**DEFENSE NUCLEAR FACILITIES
SAFETY BOARD**

August 11, 2022

Staff Report

Observations Related to the Inadvertent Tritium Release Event

Figure 1. *H-Area New Manufacturing (HANM) and nearby buildings.*

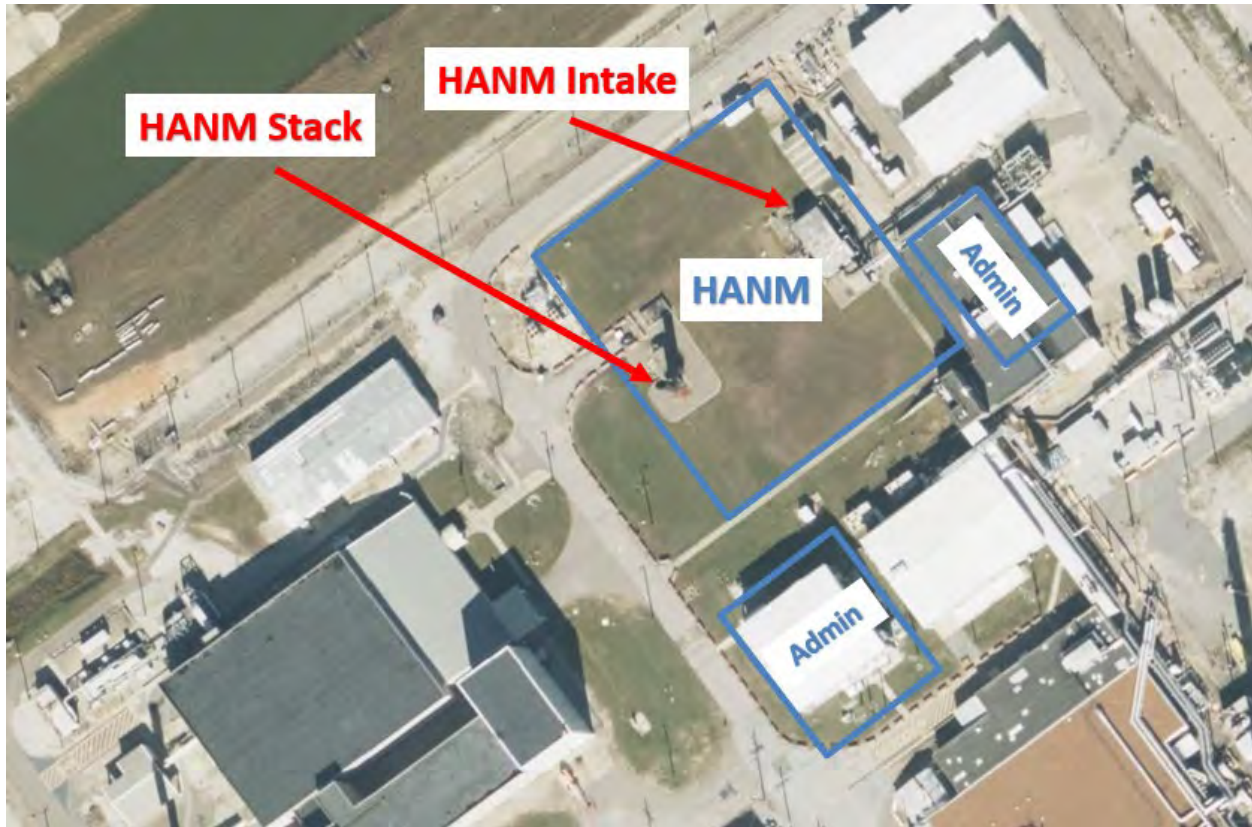
Following the event, SRNS determined that approximately 1000 curies of tritium gas from the recovered gas dryer was released from the HANM stack. The HANM ventilation supply intake, which is approximately 150 feet from the 50-foot-tall exhaust stack, pulled some of the tritium back into the facility (see Figure 1). The tritium then spread through occupied portions of the facility where tritium would not normally be found, including the corridors and control room.

Facility Design—The event at HANM demonstrated that radiological material released from a facility could get pulled back into the facility by its ventilation system. While this phenomenon is most challenging for tritium gas or vapors, which are not effectively filtered at the building’s exhaust or inlets, it is a consideration for any radionuclide. This phenomenon is not a new or unique concern. The Board raised this issue 27 years ago in DNFSB/TECH-3, *Overview of Ventilation Systems at Selected DOE Plutonium Processing and Handling Facilities* [3]. The Board also recently raised this topic in its review of the Savannah River Plutonium Processing Facility (see letter dated January 24, 2022) [4].
